Planning and Urban Design

To: City Planning Commission
From: Planning and Urban Design Staff
Date: April 12, 2021
Re: SP2021-008

Purpose:
Special Use Permit for a skills training facility and banquet facility for adults with learning disabilities.

Property Location:
1000 North 82nd Street
Kansas City, Kansas 66112

FLOOR PLAN A5

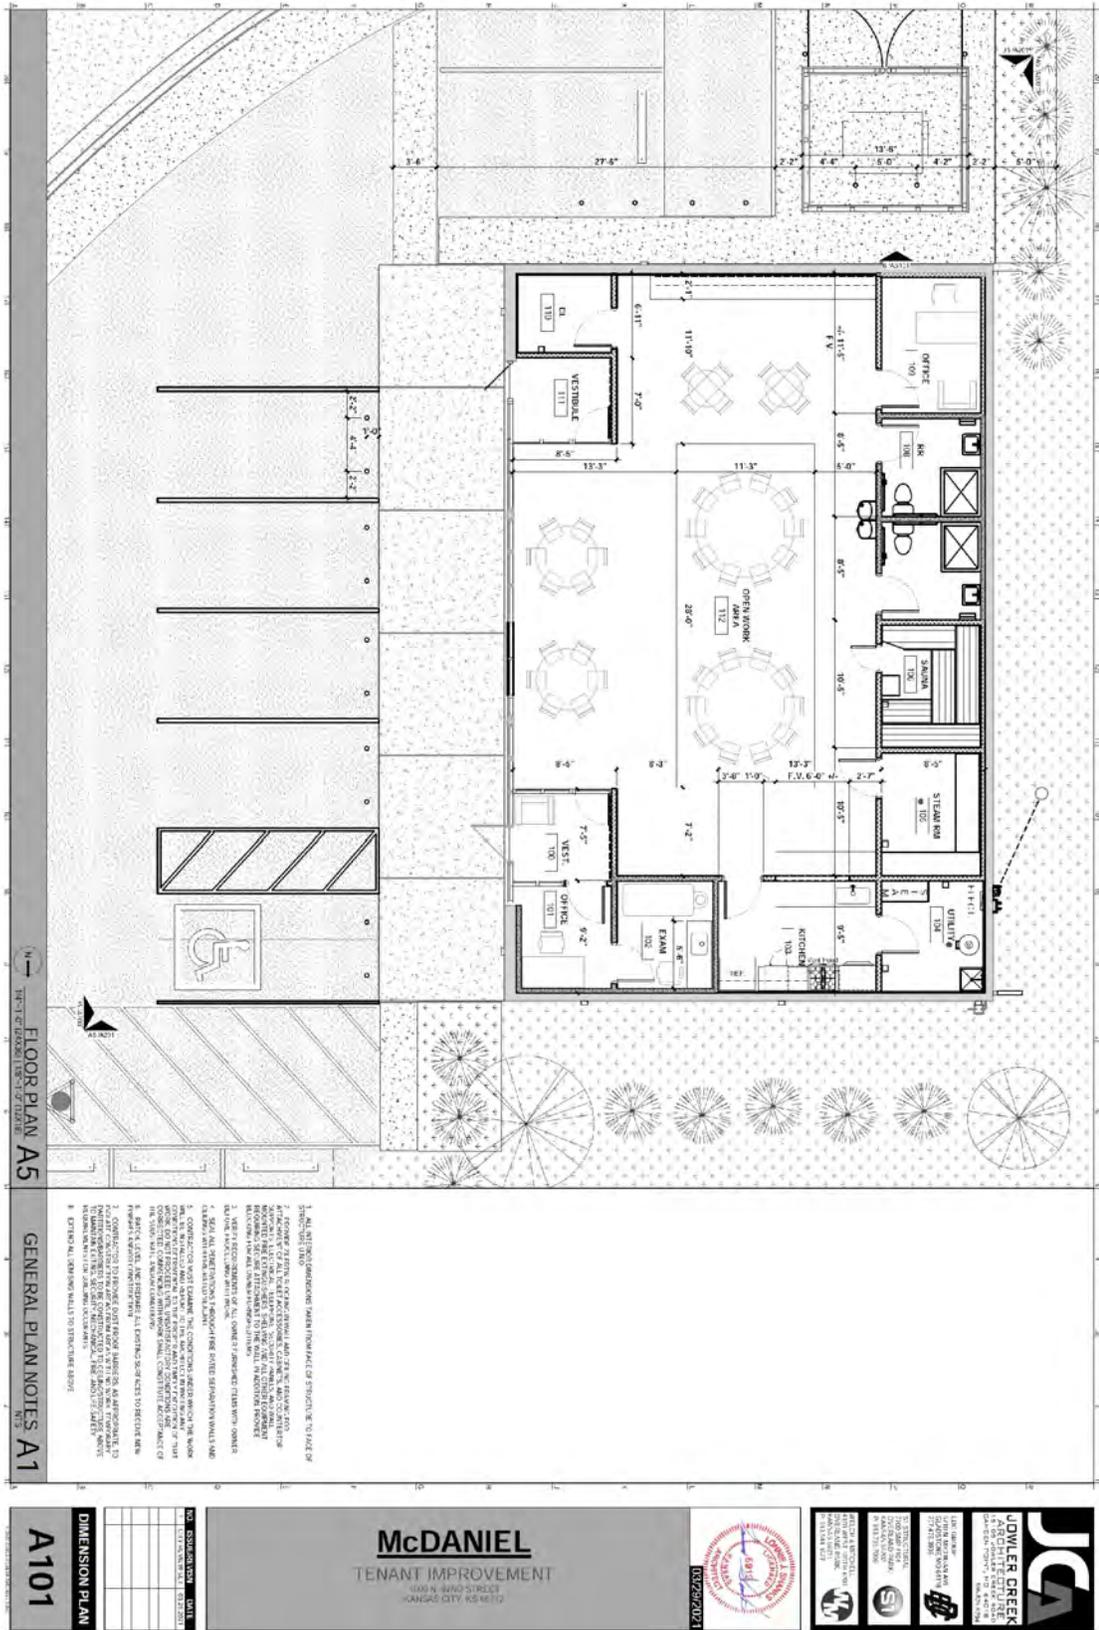
- 4) How many people will be in the building during nights and weekends (i.e. for the banquet facility)? Provide all possible floor plan configurations other than the plan submitted, such as row seating for a wedding ceremony. Different configurations may result in different parking requirements.

- ii. Per Section 27-668(a)(11), places of assembly require one (1) parking space for every four (4) seats. How many people will the building seat as a banquet facility? Regardless of the above parking requirements, per Section 27-668(b), any use not included in the parking requirements found in Section 27-668 shall be assigned a parking requirement by the City Planning Commission.

Applicant Response: *40.*

Staff Response: The applicant has provided a floor plan configuration demonstrating 40 seats, which can be found in the “Attachments” section of this report. No banquet seating arrangement may exceed 40 seats.

Applicant Response: Seating arrangement has been shown. Refer to drawings.

Staff Response: The applicant has provided a floor plan configuration demonstrating 40 seats, which can be found in the "Attachments" section of this report. No banquet seating arrangement may exceed 40 seats.
